One Carrington SSD and Concept Plan (Mod 2)

Attachment A - Response to Department's Key Issues

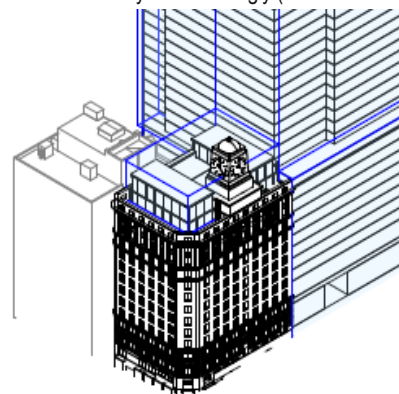
21. The department notes the visibility of the rear portion of the proposed Shell House roof-top restaurant pavilion in the Hunter Street view (View 17 and 18) and is concerned that this element may visually compete with the Shell House clock. Options are required for the further consideration of the design and height of the proposed pavilion in this location.

The Concept Plan approved an addition of up to RL 73.6 across the top of Shell House, with a 6m setback to Carrington and Margaret Streets. Although the Concept Approval allows for massing to be built in front of the clock which would obscure certain views, the proposal adopts an alternative approach: that is to maximise views of the restored clock. A perspective showing the proposal is 2.36m lower than the approved envelope is provided below.
